NAVIGATION - GPS-4000S GLOBAL POSITIONING SYSTEM SOFTWARE UPDATE

SL560XL-34-27
Page 1 of 2

NO SUPPORT TO PERFORM LOCALIZER PERFORMANCE WITH VERTICAL (LPV) AND REQUIRED NAVIGATION PERFORMANCE (RNP) LESS THAN 0.3 NAUTICAL MILE APPROACHES OVER ALASKA

NAVIGATION - GPS-4X00() - SOFTWARE UPDATE FOR UNIVERSAL TIME COORDINATED (UTC) TIME OFFSET AND GNSS POSITION NEAR 180 DEGREES WEST LONGITUDE (CONVERTS BLACK LABEL CPN 822-2189-100 TO BLACK LABEL CPN 822-2189-101)

Map
Figure 1

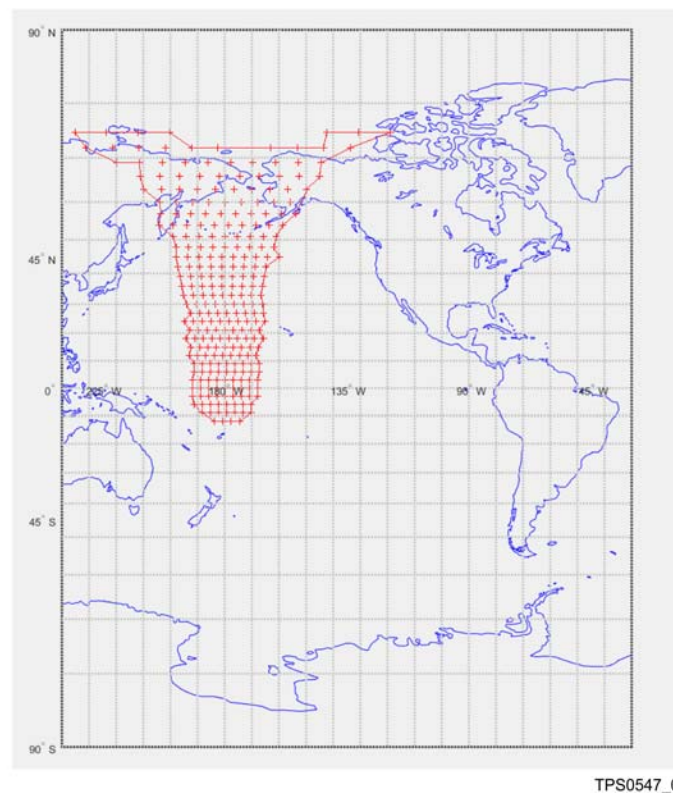
- (1) The Root Cause has been identified as an improper implementation in the computation of the longitude at which the GPS signal penetrates the ionosphere when the satellite is located across 180 degrees W Longitude.
- (2) The affected region is limited to the area within the solid red line boundary indicated in the attached map. The region extends 20 degrees on either side of 180 degrees W Longitude and extends from the Northern Hemisphere to 10 degrees Latitude in the Southern Hemisphere. Refer to Figure 1.

- (3) The potential reduction in position accuracy caused by the computational issue prevents the GPS-4000S, CPN 822-2189-100, from supporting LPV approaches at LPV-equipped airports in the affected region.
- (4) Un-announced, but bounded reduced positional accuracy in the affected region limits operations to RNP 0.3 NM, or higher (Positional error will be bounded to 0.3 NM but may not be bounded by the protection level (HPL) that is output by the GNSS).

- (1) A software update that corrects this issue is targeted to be available in Q1 2020.
- (2) Until that software update is available, operational limitations will need to be applied. The operational limits are:
 - (a) Do not use the GPS-4000S, CPN 822-2189-100, to perform LPV approaches at airports in Alaska listed below. There are no airports outside of Alaska that are in the affected region that support LPV approaches at the time of this SIL publication. LPV-equipped airports will be monitored on every database update and if additional LPV-equipped airports are identified, this SIL will be updated.
 - (b) Do not perform operations that require an accuracy better than RNP 0.3 NM (For example, 0.1, 0.11, 0.15, etc.) in the region identified in the above map (+/- 20 degrees of 180 degrees W Longitude) or at the airports in Alaska listed below.

- (c) Other GPS-based approach types that require a position accuracy greater than or equal to RNP 0.3 NM (For example, 0.3, 1, 2, 4, 10, etc.) can be flown (i.e. Lateral Navigation (LNAV) / Vertical Navigation (VNAV)).
